## Memorandum

**To:** Dana Valleau, TRC Augusta, ME      **Project No.:** 165796

**Subject:** **Sisk Mountain (Kibby Expansion)  
Summary and Response to LURC  
Comments**

Figure 1 – Kibby Cumulative Project Noise Contour Map Utilizing “o” Ground Cover

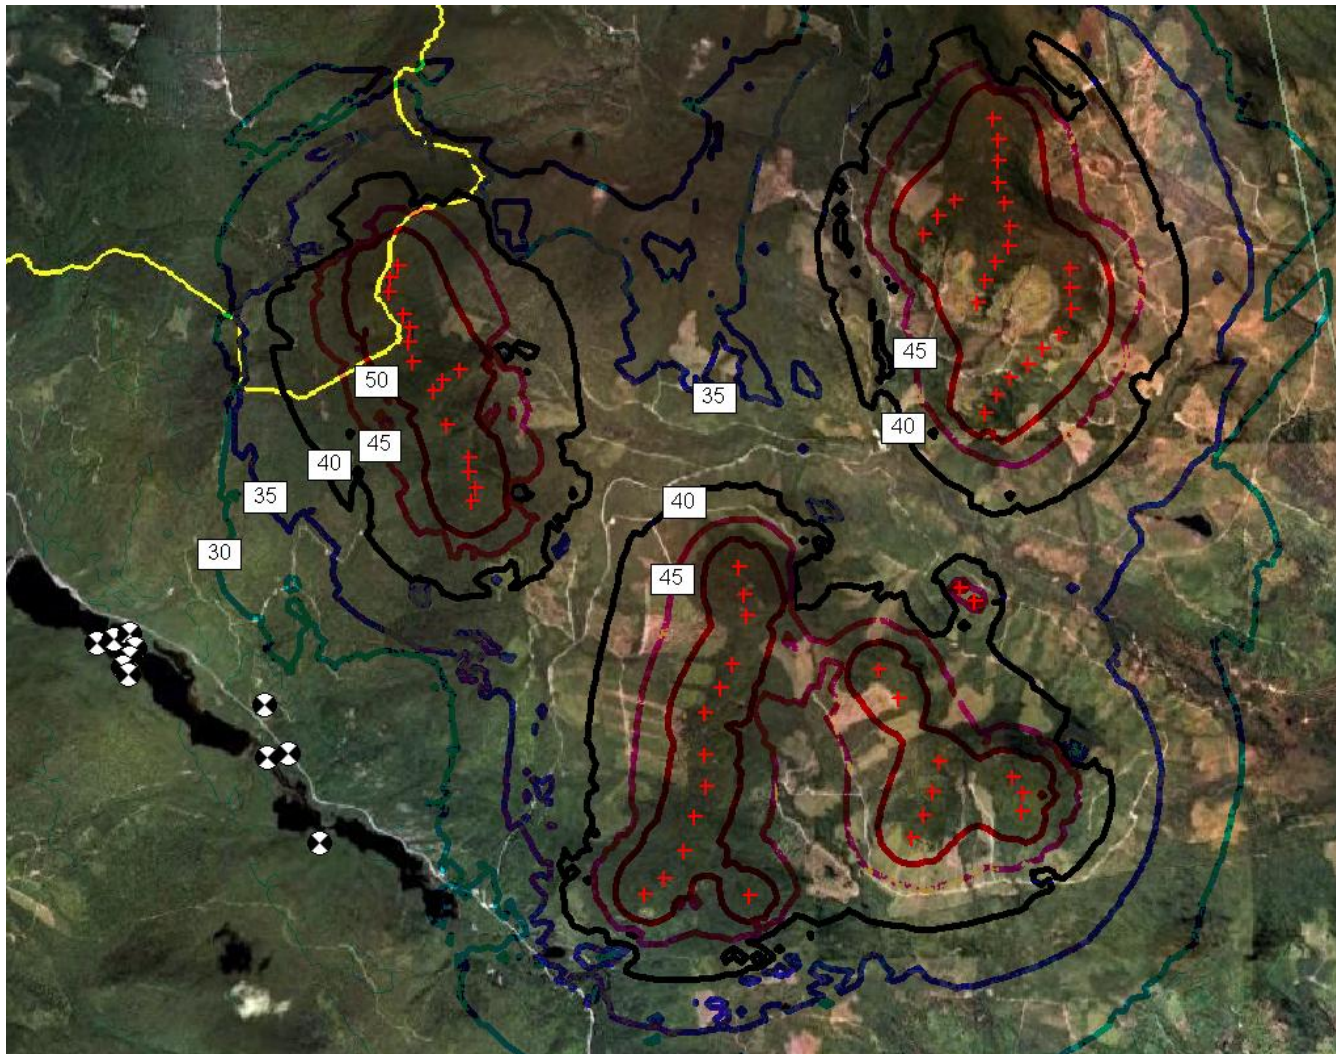
A review of the data in Table 2 reveals that the cumulative projects, maintaining the same extremely conservative acoustically reflective ground cover of “0” and adding an additional 3 dBA for modeling uncertainty, still results in sound levels of 25.6 dBA or lower at protected areas, well below the MDEP limit of 45 dBA for protected areas. Utilizing the more realistic, yet still conservative mixed ground cover of “0.5” results in calculated noise levels of 22.8 dBA or lower at all protected locations. Noise contour maps of the cumulative projects for both the “0” and “0.5” ground cover settings are provided as Figures 1 and 2 to this memo.
